Form 3160-5 (June 2019)

SUNDRY NOTICES AND REPORTS ON WELLS 6. If Indian, Allottee or Tribe Name Do not use this form for proposals to drill or to re-enter an abandoned well. Use Form 3160-3 (APD) for such proposals. 7. If Unit of CA/Agreement, Name and/or No. SUBMIT IN TRIPLICATE - Other instructions on page 2 1. Type of Well 8. Well Name and No. STARK 33 FED COM/705H Oil Well Gas Well Other 9. API Well No. 3001548602 2. Name of Operator EOG RESOURCES INCORPORATED 3a. Address 1111 BAGBY SKY LOBBY 2, HOUSTON, TX 77(3b. Phone No. (include area code) 10. Field and Pool or Exploratory Area (713) 651-7000 PURPLE SAGE; WOLFCAMP 11. Country or Parish, State 4. Location of Well (Footage, Sec., T.,R.,M., or Survey Description) SEC 33/T25S/R30E/NMP EDDY/NM 12. CHECK THE APPROPRIATE BOX(ES) TO INDICATE NATURE OF NOTICE, REPORT OR OTHER DATA TYPE OF SUBMISSION TYPE OF ACTION Acidize Production (Start/Resume) Water Shut-Off Deepen ✓ Notice of Intent Well Integrity Alter Casing Hydraulic Fracturing Reclamation Casing Repair New Construction Recomplete **✓** Other Subsequent Report Change Plans Plug and Abandon Temporarily Abandon Final Abandonment Notice Convert to Injection Plug Back Water Di

500' FSL 1799' FWL **Proposed Wellbore**

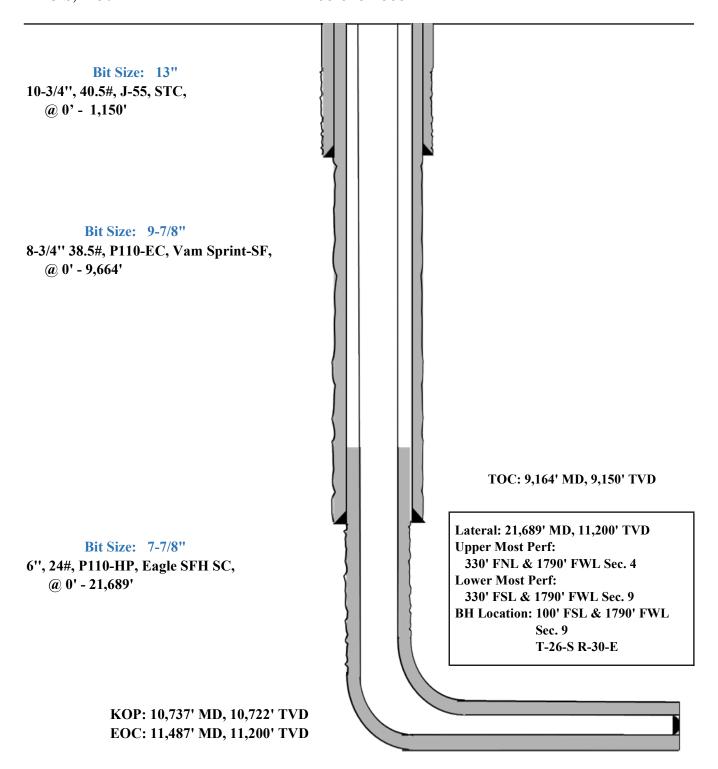
Hole	Interval MD		Interva	al TVD	Csg			
Size	From (ft)	To (ft)	From (ft)	To (ft)	OD	Weight	Grade	Conn
12-1/4"	0	1,150	0	1,150	9-5/8"	36#	J-55	LTC
8-3/4"	0	9,664	0	9,650	7-5/8"	29.7#	HCP-110	FXL
6-3/4"	0	9,164	0	9,150	5-1/2"	20#	P110-EC	DWC/C IS MS
6-3/4"	9,164	9,664	9,150	9,650	5-1/2"	20#	P110-EC	Vam Sprint SF
6-3/4"	9,664	21,689	9,650	11,200	5-1/2"	20#	P110-EC	DWC/C IS MS

Variance is requested to waive the centralizer requirements for the 7-5/8" casing in the 8-3/4" hole size. An expansion additive will be utilized, in the cement slurry, for the entire length of the 8-3/4 hole interval to maximize cement bond and zonal isolation.

Variance is also requested to waive any centralizer requirements for the 5-1/2" casing in the 6-3/4" hole size. An expansion additive will be utilized, in the cement slurry, for the entire length of the 6-3/4" hole interval to maximize cement bond and zonal isolation.

Variance is also requested to waive the annular clearance requirements for the 5-1/2" casing by 7-5/8" casing annulus to the proposed top of cement.

EOG requests variance from minimum standards to pump a two stage cement job on the 7-5/8" intermediate casing string with the first stage being pumped conventionally with the calculated top of cement at the Brushy Canyon (5,705') and the second stage performed as a 1000 sack bradenhead squeeze with planned cement from the Brushy Canyon to surface. If necessary, a top out consisting of 100 sacks of Class C cement + 3% Salt + 1% PreMag-M + 6% Bentonite Gel (2.30 yld, 12.91 ppg) will be executed as a contingency. Top will be verified by Echo-meter.

500' FSL 1799' FWL **Revised Wellbore**

Figure 1: Cameron TA Plug and Offline Adapter Schematic

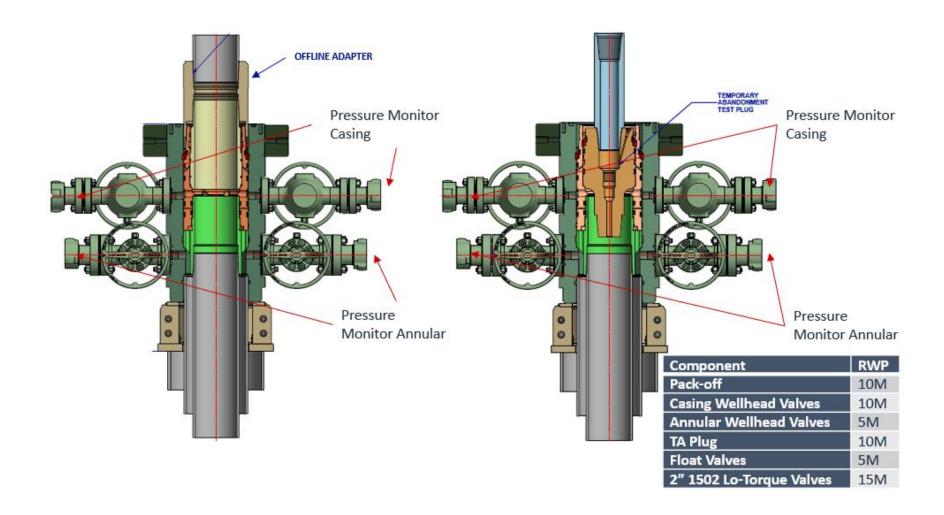
- c. Return line schematics can be seen in Figure 3.
- 10. Remove TA Plug from the casing.
- 11. Install offline cement tool.
 - a. Current offline cement tool schematics can be seen in Figure 1 (Cameron) and Figure 2 (Cactus).

Figure 4: Rig Placement Diagram

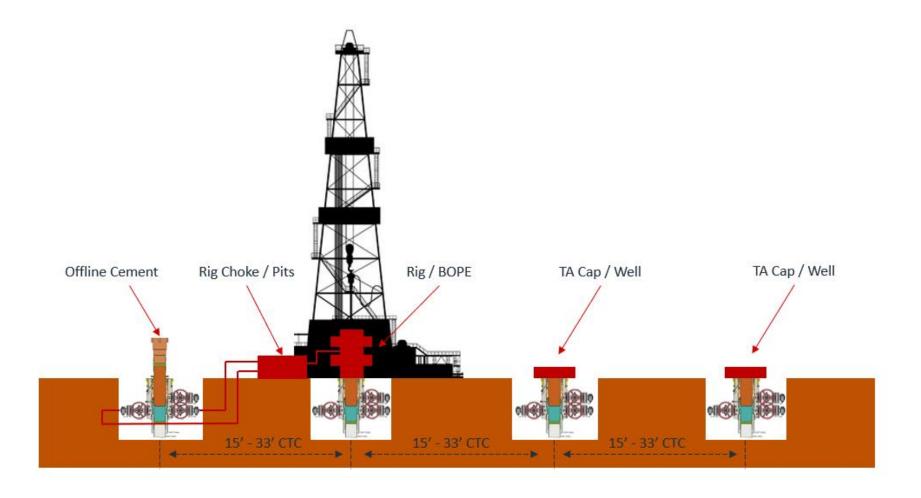
- e. Diagram for rig positioning relative to offline cementing can be seen in Figure 4.
- 9. Rig up return lines to take returns from wellhead to pits and rig choke.
